MITSUBISHI HEAVY INDUSTRIES, LTD.
16-5, KONAN 2-CHOME, MINATO-KU
TOKYO, JAPAN

Docket No. 52-021
MHI Ref: UAP-HF-09473

Subject: MHI's Responses to US-APWR DCD RAI 427-2909 Rev.1, 428-2910 Rev.1 and 429-3178 Rev.1

Figure 1 Dose Rate Distribution of Fission Chamber, Detector and Drive Cable

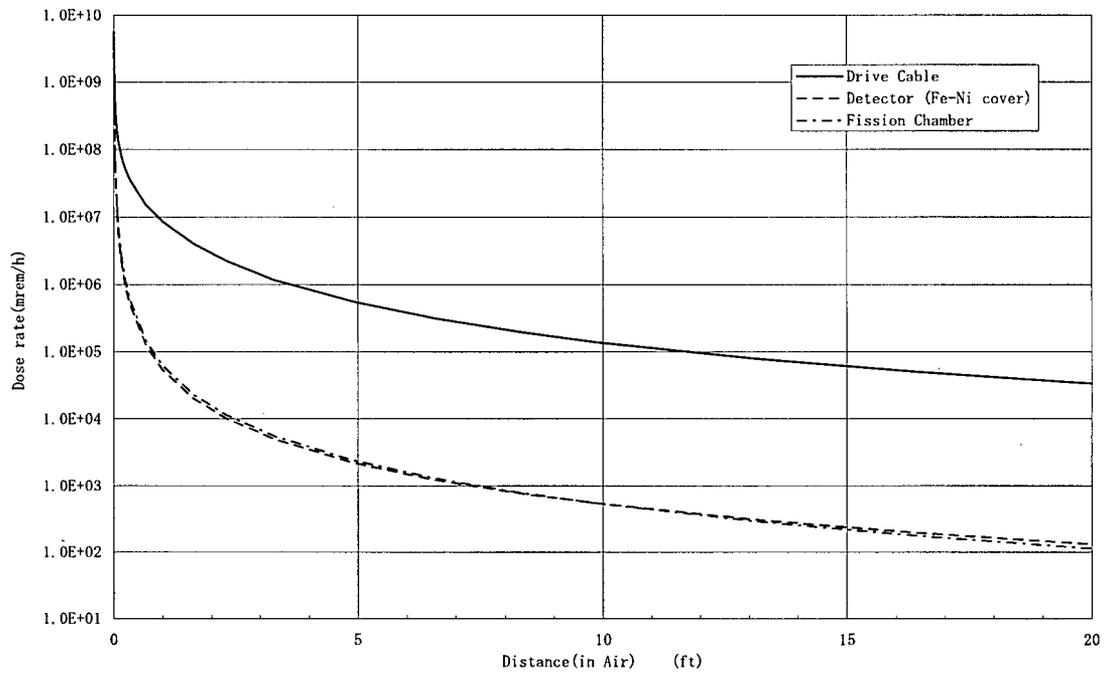
- As noted in US-APWR FSAT Tier 2 Section 7.7.1.5.2, the ICIS detectors are miniature fission detectors. Table 12.2-71 "Parameters and assumptions for Calculating Irradiated Incore Detector, Drive Cable and Flux Thimble Source Strength" does not show the source term and dose rates associated with these fission detectors.

Describe the dose rates, and their bases, for the fission chambers of the In Core Instrument System neutron detectors, or provide the specific alternative approaches used and the associated justification.

The source strengths of the ICIS detectors were calculated using the ORIGEN code. The parameters used to determine the source strengths are presented in Table 1. The results from the code provide the Table 2 source strengths for the fission chamber of the In Core Instrument System neutron detectors. The dose rates of the fission chamber, detector (Fe-Ni cover), and drive cable were calculated using the MicroShield code where the fission chamber and detector were modeled as point sources and the drive cable was modeled as a line source. The dose rates resulting from these sources are presented in Figure 1, indicating that only the drive cable represents a significant source beyond several inches distance (in air) from the ICIS detectors.

Figure 1 Treatment of the Cubicle in the Airborne Activity Calculation (example)

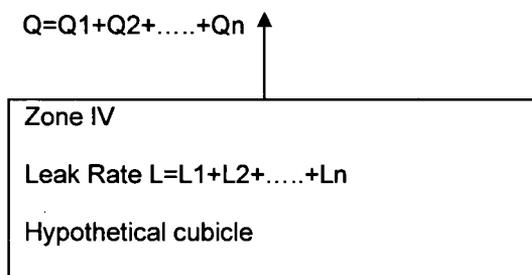
- IV) For those areas that enclose equipment that does not contain ESF fluids, the assumed leakage rates are not conservative for dose calculations, with respect to the Technical Specifications unidentified leakage rate of 1 gpm (12,000 lpd) or the identified leakage rate of 10 gpm (120,000 lpd) fluids. See the reply to Question 143-1737 12.02-11 MHI response.

As depicted in Figure 1 below, this calculation models all cubicles assigned to the same radiation zone category as a single hypothetical cubicle. Airborne activity is calculated using Eq. 3 (see the answer to 1a above) and does not depend on cubicle volume. Therefore, this treatment considers all of the cubicles in the radiological controlled area(RCA).

Radiation Zone I is not RCA. Radiation Zone II is the RCA, but the equipment leaked radioactive liquid is not installed in this Zone. The equipment leaked radioactive liquid (e.g. pumps) is installed in zone III and higher zone. Therefore, MHI will revise DCD Table 12.2-60 and Tabl2 12.2-61.
